# Access Compliance Report

## Public Rights-of-Way

| Intersection ID: 17455                  | Main Street: IDLEWILD_RD | Cross Street: LYNWORTH_PL               | Location: SW           |
| ADA ID: 3C858C24C0EE                    | Ramp Type: PerpDiag      | Initial Pass/Fail: Fail                 | Overall Compliance: No |

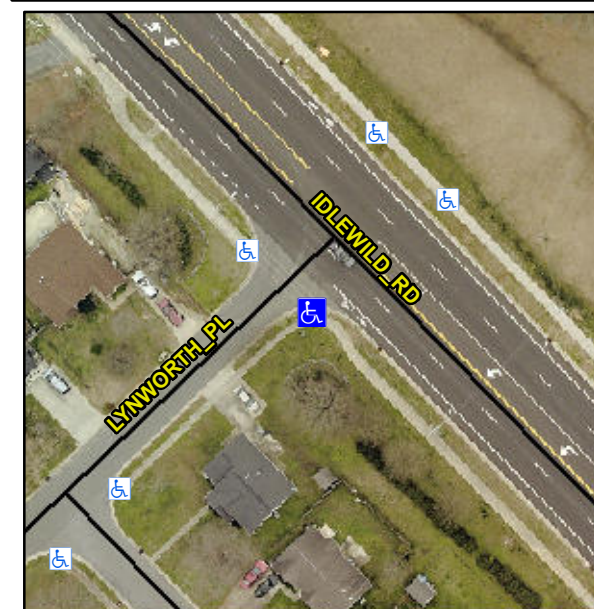
**Not Found, R304.5.1, R304.2.2**

| Compliance | Description           | Data  | Compliance | Description                 | Data  |
|------------|-----------------------|-------|------------|-----------------------------|-------|
| N/A        | Ramp Length (in)      | 51.0  | No         | Ramp Slope (%)              | 11.0  |
| No         | Ramp Width (in)       | 41.0  | Yes        | Ramp XSlope (%)             | 0.7   |

**Remove & Replace Curb Ramp With Two New Directional Ramps or Equivalent.**
